Wisconsin Department of Transportation

Proposal #19: 1420-22-71, WISC 2015 578
Fond du Lac Bypass
CTH V Interchange
USH 151
Fond du Lac County

This is Addendum No. 01, which provides for the following:

ADDENDUM NO. 01

Addendum No. 01
 ID 1420-22-71
 Added Sheet 22A
 November 4, 2015

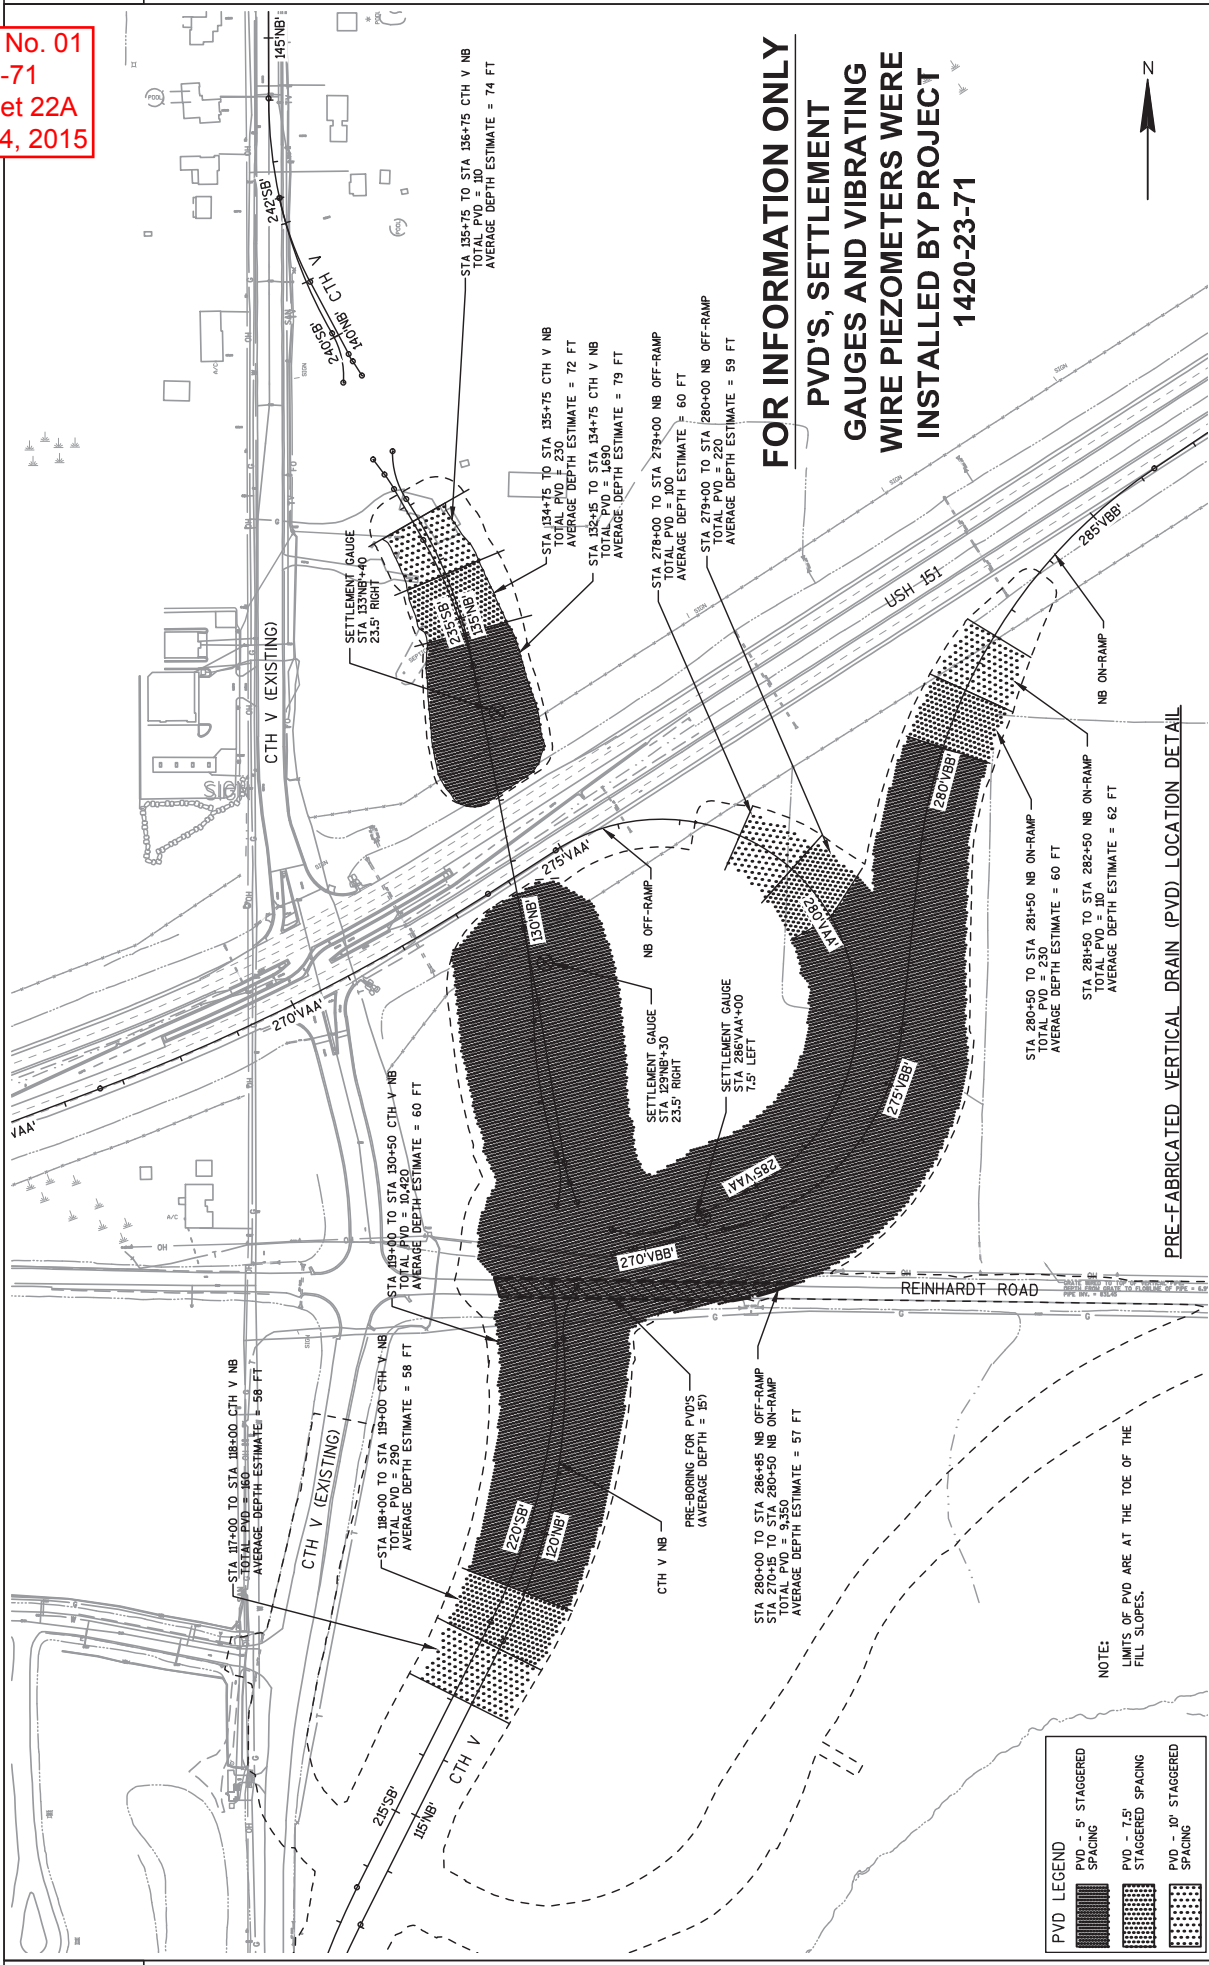
Added Plan Sheets	
Plan Sheet	Plan Sheet Title (brief description of why sheet was added)
22A	Construction Detail – PVD Location Detail

Addendum No. 01
 ID 1420-22-71
 Revised Sheet 40
 November 4, 2015

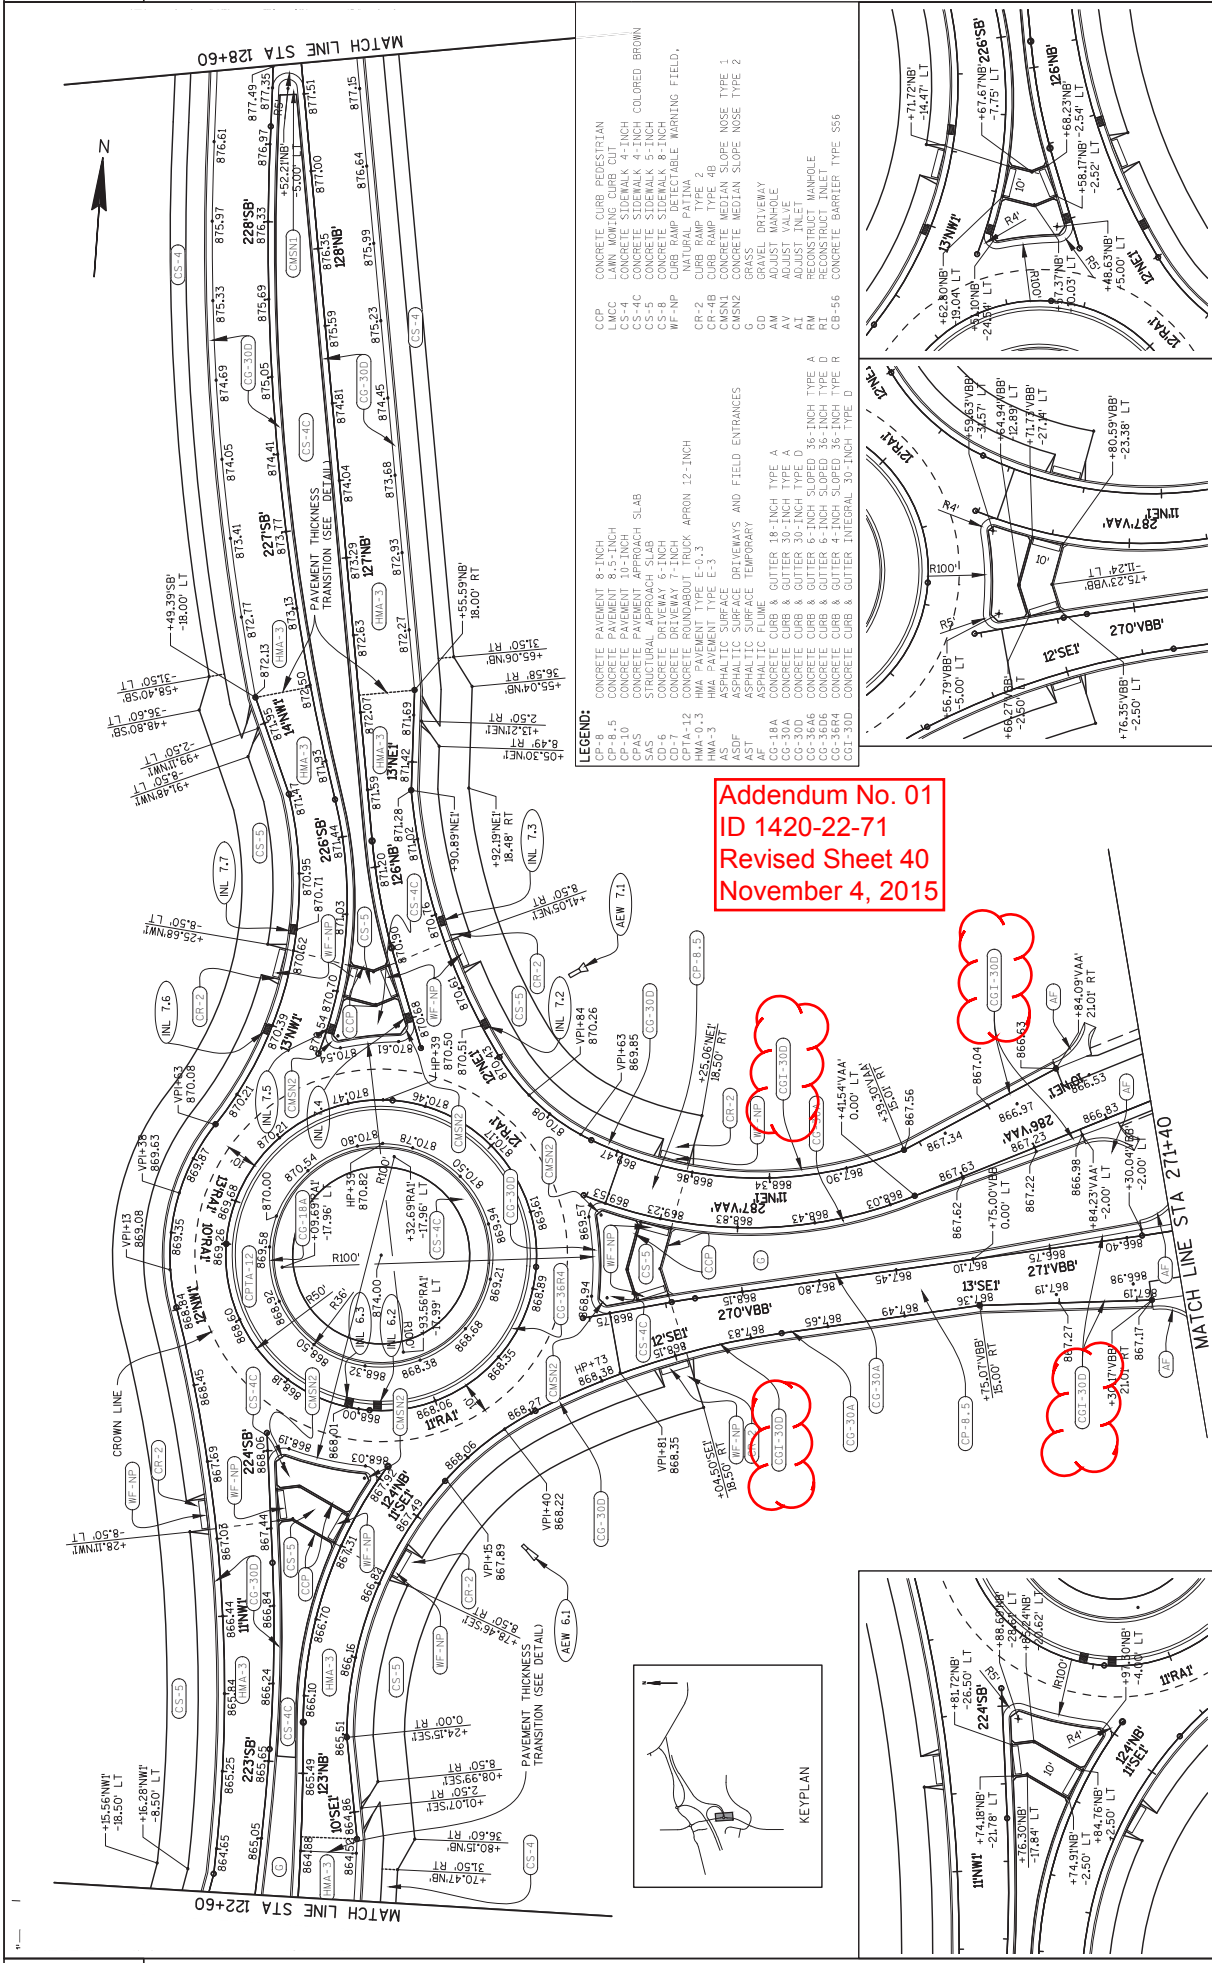
Revised Plan Sheets	
Plan Sheet	Plan Sheet Title (brief description of changes to sheet)
40	Paving Detail – CTH V – added label for CGI-30D
46	Paving Detail – Frontage Road – added label for CGI-30D
266	MQ – Concrete Curb and Gutter Items – revised quantity for 601.0409 and 601.0452
